81 Latrobe Avenue, Alphington

This peer review of the MEL Consultants Environmental Wind Speed Measurements report (MEL Consultants Report 165-19-WT-ENV-03) is based on Vipac's experience as a wind-engineering consultancy.

Figure 1: Polar plot of wind speed at location T1 (Level 10 terrace)

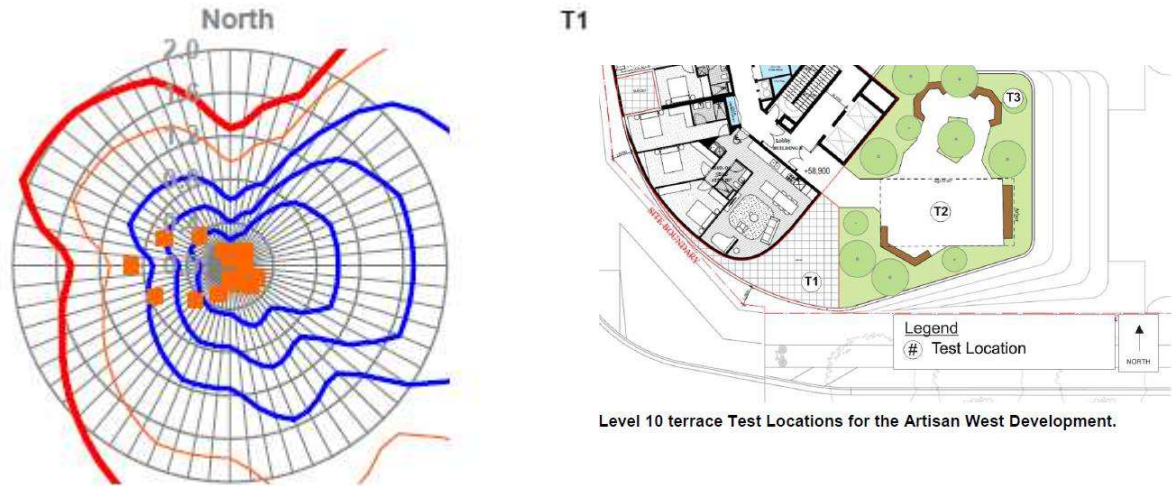
- vi. The report concluded that the wind conditions at the Level 10 terrace of Building B with a 1.6 m high balustrade have been shown to be within the walking comfort criterion for all wind directions. However, this is not consistent with the results of polar plot in the report which

shows that Location T1 measured wind speeds exceeding the walking criterion for westerly winds (see Figure 1 below, cited from the report). MEL Consultants should clarify if these results are correct, and if so, additional wind control measures may be necessary to rectify this.

For the wind conditions on Location T1 at the Level 10 terrace of Building B, MEL Consultants should provide clarification of whether the conclusion in main report or the results in the polar plot are correct; If the results shown in Figure 1 are correct, then additional wind control measures may be necessary to rectify this.
